STONEBOROUGH 2ND ADDITION

RE: S/D 99-70 -- One-Step Final Plat of STONEBOROUGH 2ND ADDITION

STAFF REPORT
(One-Step Final Plat Approved 11/4/99)

CASE NUMBER: S/D 99-70 - STONEBOROUGH 2ND ADDITION

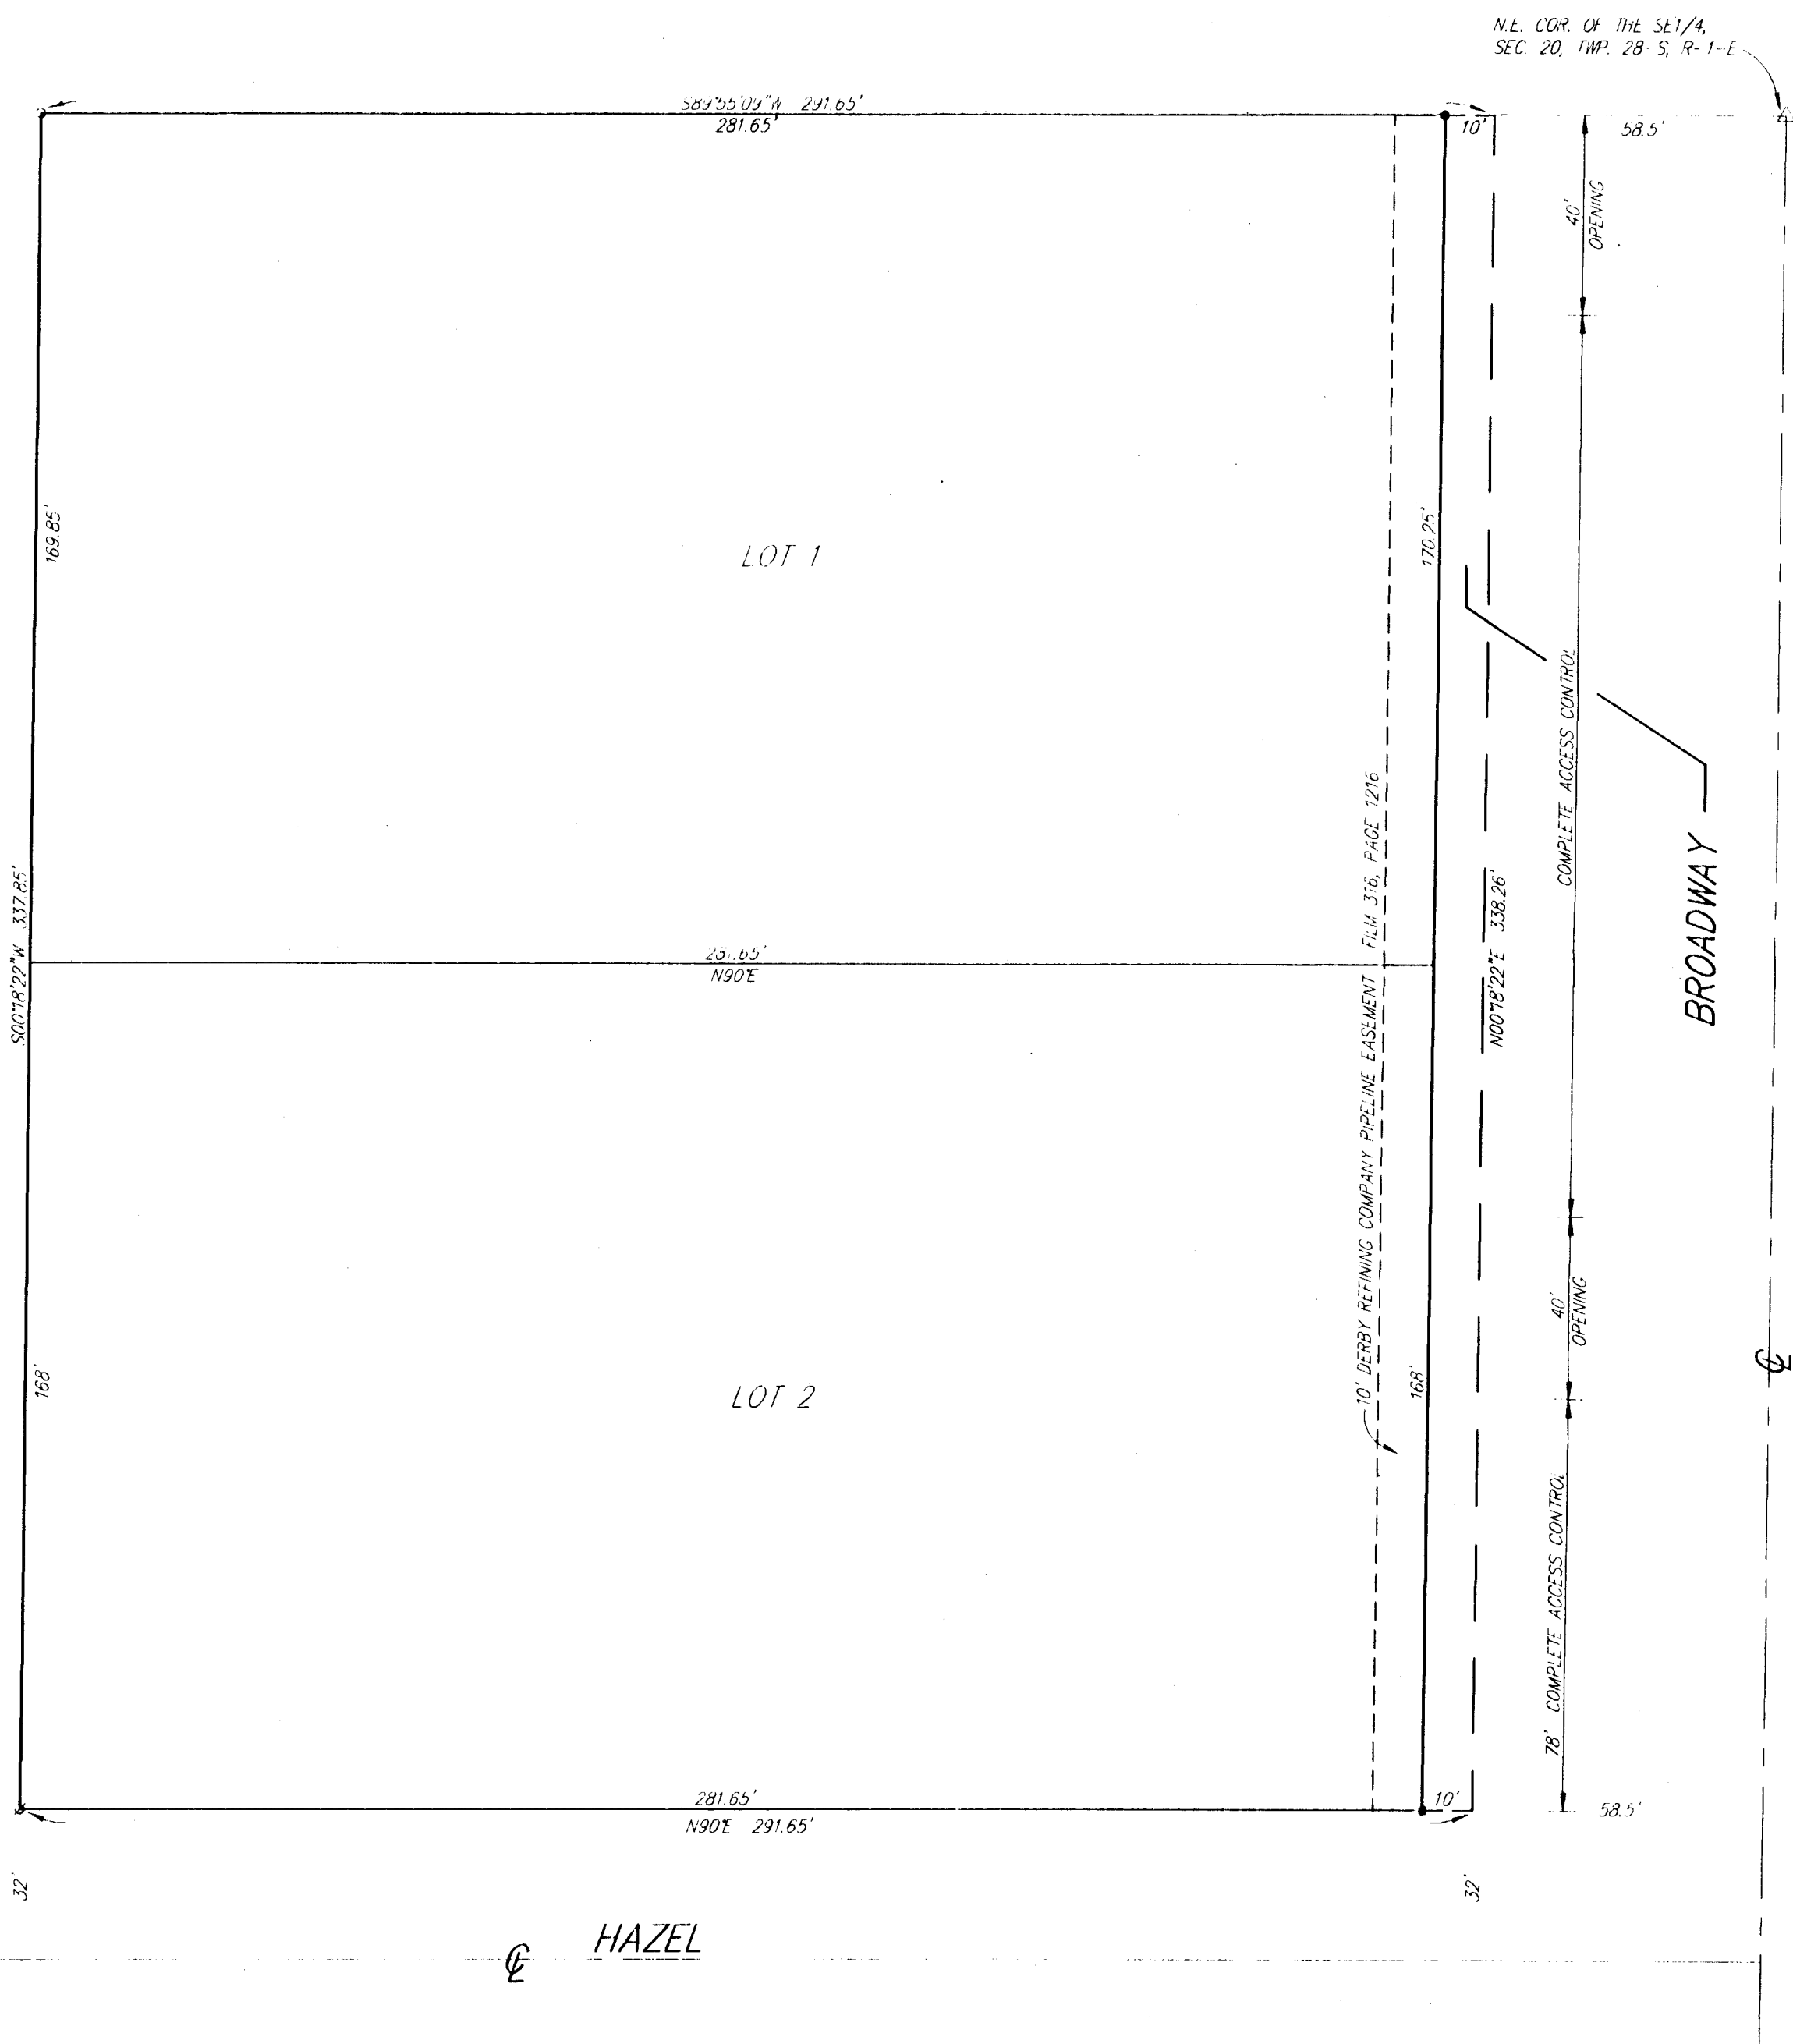
- D. Traffic Engineering needs to comment on the access controls. The plat proposes three access openings along Broadway, including one joint access. Distances should be shown for all segments of access control. Traffic Engineering has approved one access opening per lot. The Subdivision Committee has approved the plat with two openings subject to concurrence by KDOT.

- ✓ E. The MAPC signature block should be revised to reference "Francis S. Garofalo" as the MAPC Chairman.

- G. The applicant's agent shall determine any setback requirements for the pipelines by researching the text of the pipeline agreements. If a setback from the pipeline easements is provided for in the pipeline easement agreements, it shall be indicated on the face of the plat.

-  I. The dimension along the north line of the plat needs to be revised to correspond with the legal description.
- J. The plat's text shall include language that a drainage plan has been developed for the plat and that all drainage easements, rights-of-way, or reserves shall remain at established grades or as modified with the approval of the applicable City or County Engineer, and unobstructed to allow for the conveyance of stormwater.

- A. Two openings are permitted; one opening to be located along the north property line to allow for possible future shared access with the adjoining property to the north, the south opening to be located in alignment with the existing opening across Broadway to the Colonial Heights Addition.
- B. The applicant shall dedicate 10 feet of additional right-of-way along Broadway.
